# ADDENDUM NO. 3 TO CONTRACT DOCUMENTS FOR CITY OF MANISTIQUE MARINA RENOVATION PROJECT – PHASE II

## JULY 16, 2018

This Addendum No. 3 consists of 4 pages.

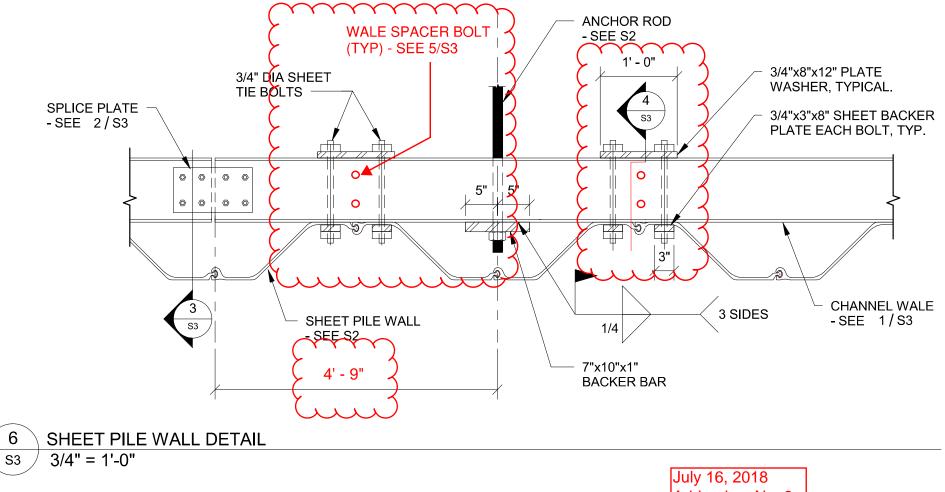
- 1. Maximum tie-rod spacing on the sheet pile wall is 9'-6".
- 2. Sheets are to be as called out in the Sheet S2 keynotes; a cold formed sheet is acceptable.

9 RETURN WALL CORNER BRACE DETAIL S3 1" = 1'-0"

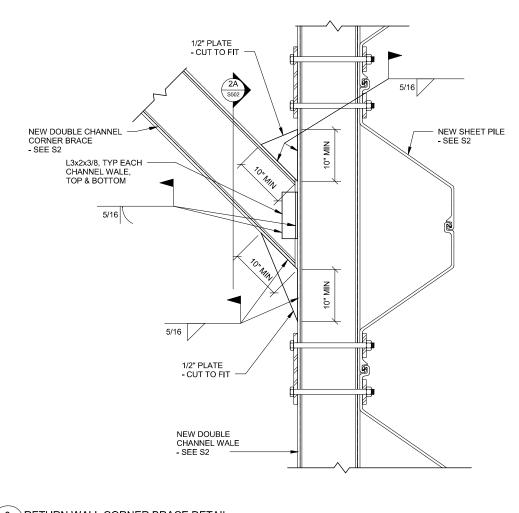
- 1. Plan Sheet S2: Edited drawing detail provided in bump-out area.
- 2. Plan Sheet S3: Revised Detail 6/S3 indicates wale spacer bolt and revised dimension.
- 3. Plan Sheet S3: New Detail 9/S3 Return Wall Corner Brace Detail.
- 4. Plan Sheet S3: New Detail 10/S3 Brace Connection Detail.
